Construction and Stormwater Inspection

Operator: ST CROIX OPERATING INC - 81490

Location ID: 474453

Inspection Photos
Location Name: Alice Seedorf 1
Location ID: 474453

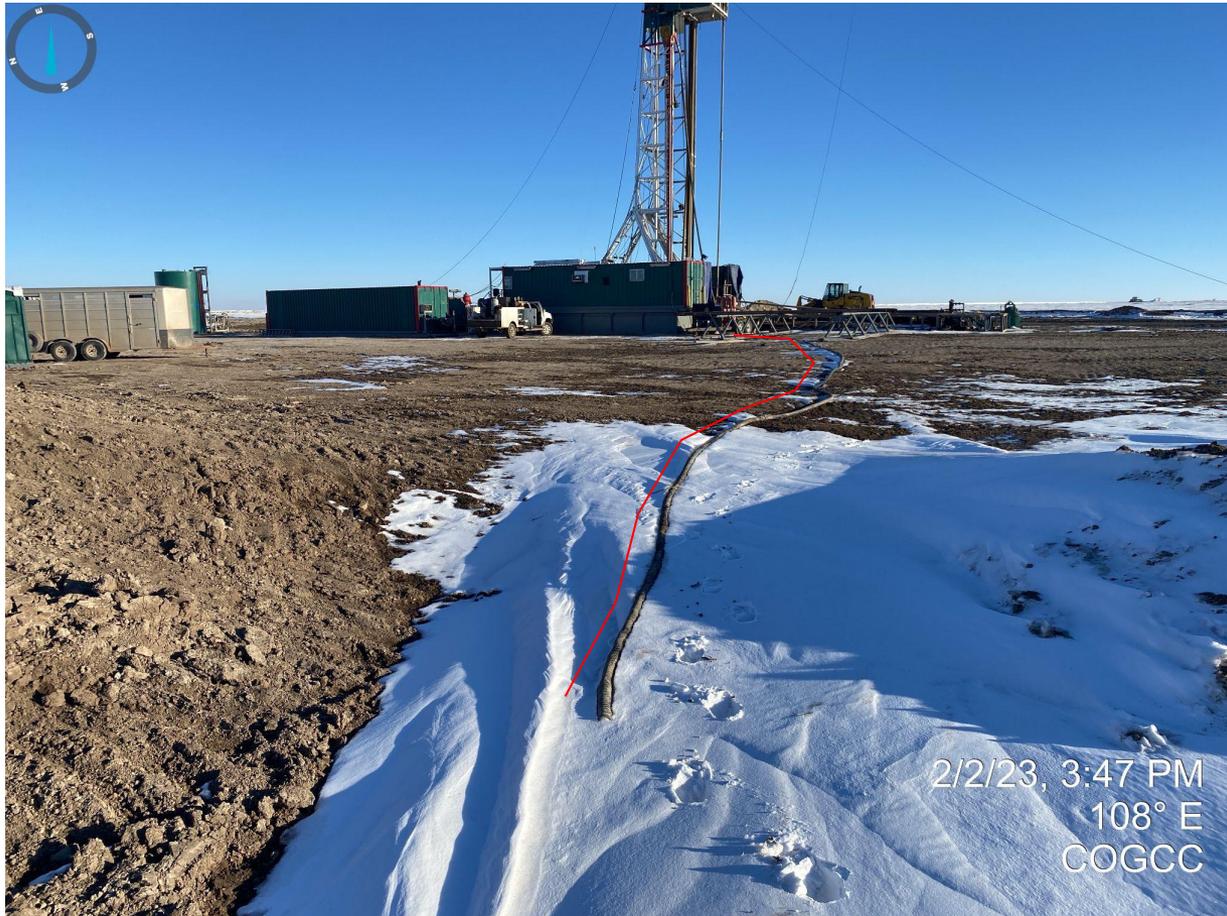
Photo 19. Facing east near the sediment trap on the northwest corner of the location. Red line indicates a line originating from the drill rig. On site crew members were unable to verify what the line was being used for. This is not in compliance with 1002.f.(2)B as materials should not be discharged into the stormwater BMPs (e.g. ditch or sediment trap).
